BEACON PLANNING BOARD
Via Video-Conference
BEACON, NEW YORK 12508
Phone (845) 838-5002 Fax (845) 838-5026

Beacon Views - Conklin Street

Continue public hearing for SEQRA environmental review on applications for Subdivision and Site Plan Approval, "Beacon Views Townhouses" 40 units, Conklin Street, submitted by Beacon Views, LLC

RE: Beacon Views Site Plan and Conservation Subdivision
Conklin Street
Beacon, New York
Tax Parcel ID: 6055-03-331123

WETLAND MITIGATION PLAN

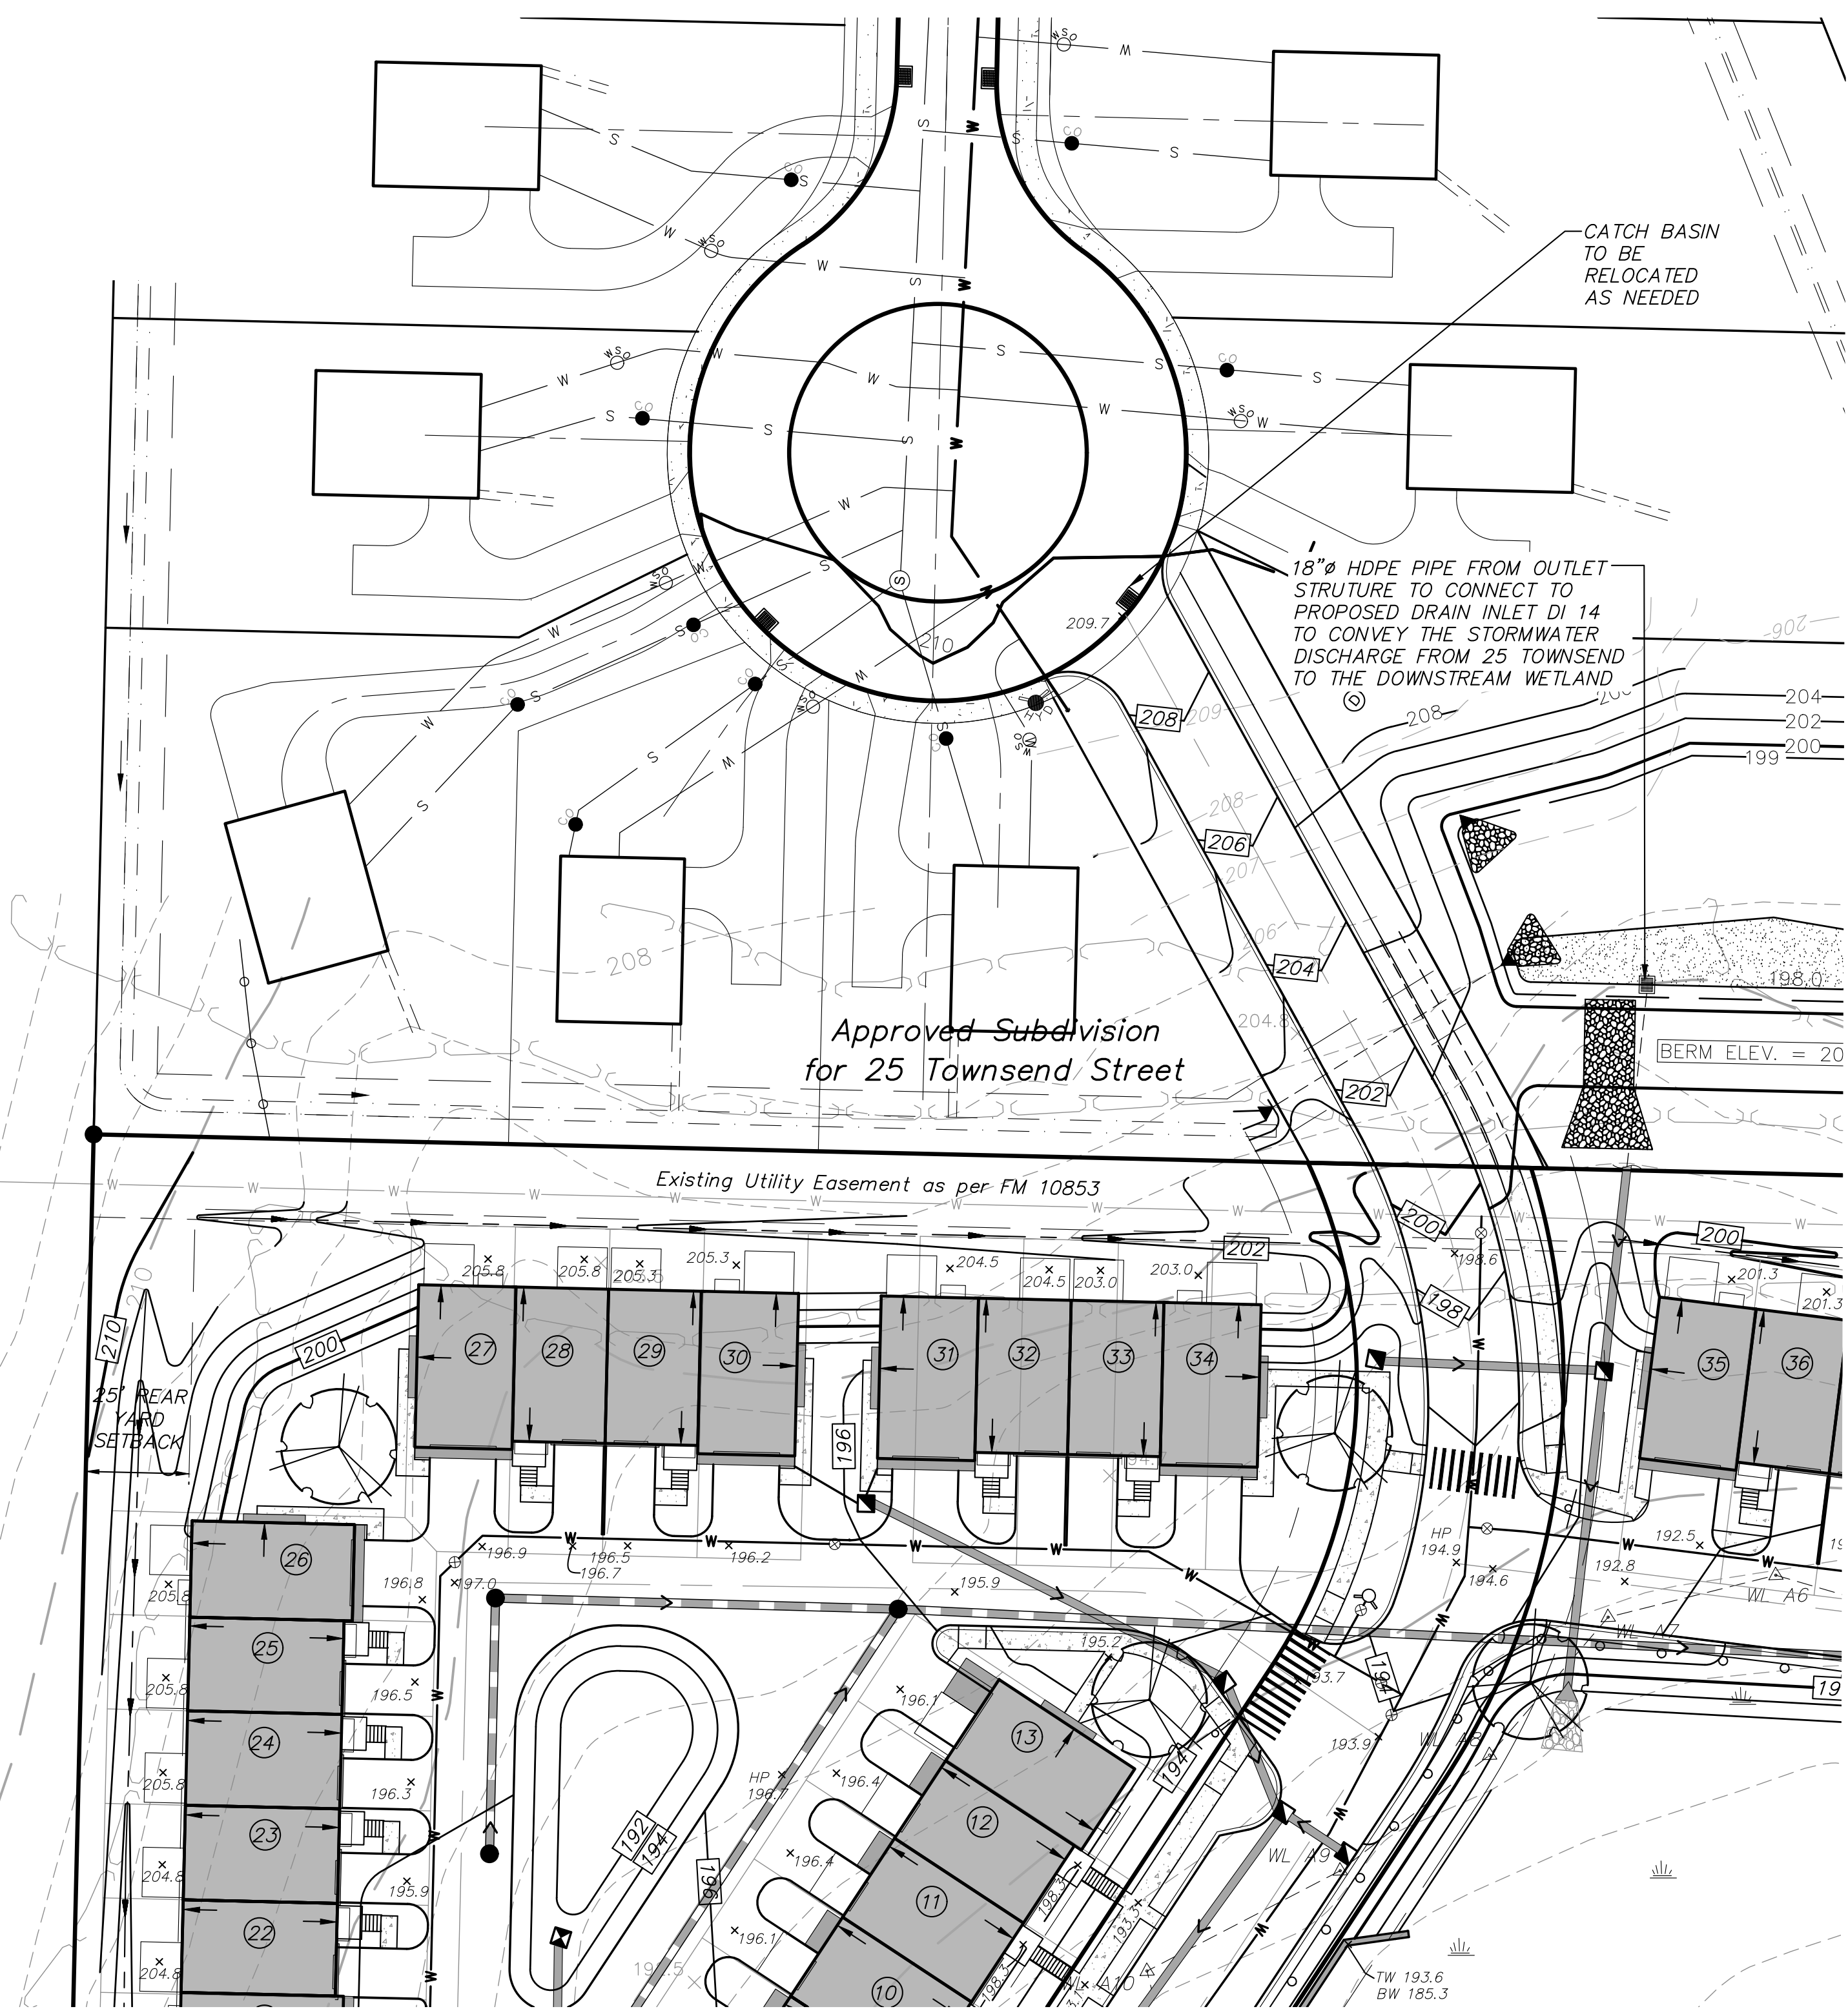
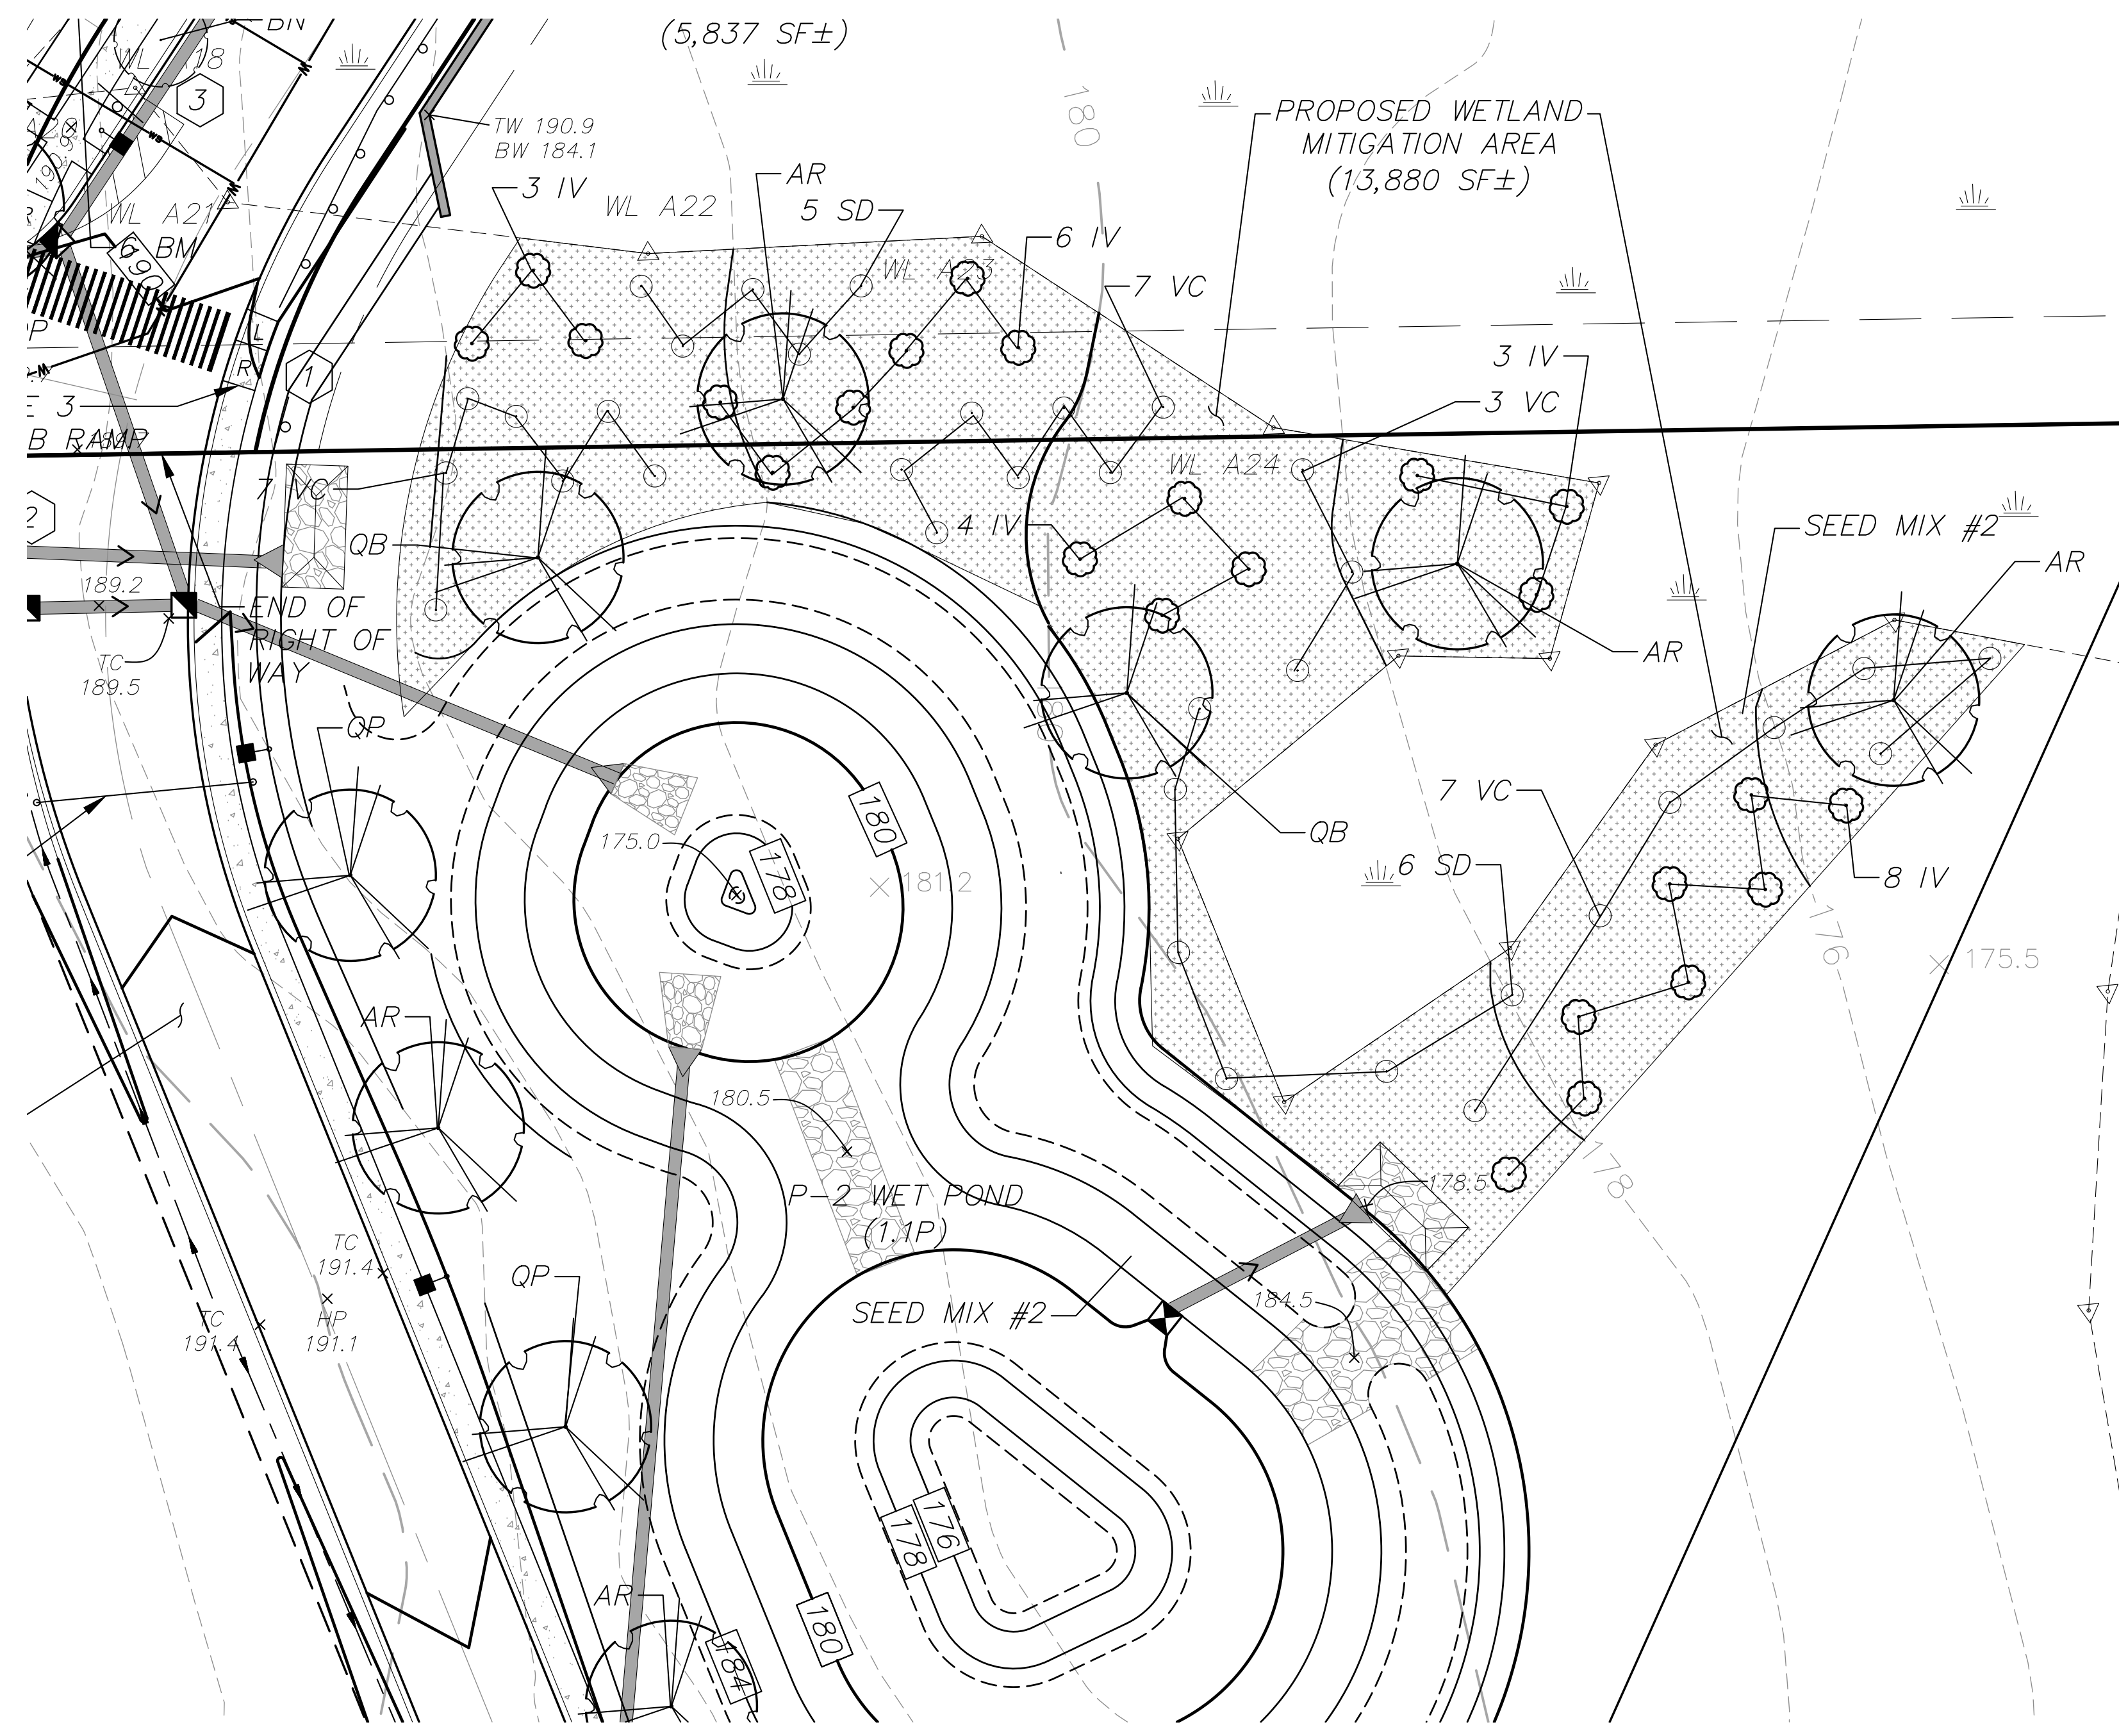
5. For Sheet SP-4, if the option for an emergency access to Conklin Street is required, the plans should provide information on any additional wetland area that will have to be filled and any necessary modifications to the wetland mitigation plan.

1. The revised Wetland Report addresses the Federal and State Threatened and Endangered species.
2. A detailed Wetland mitigation Plan has been provided on sheet SP-5 as requested.
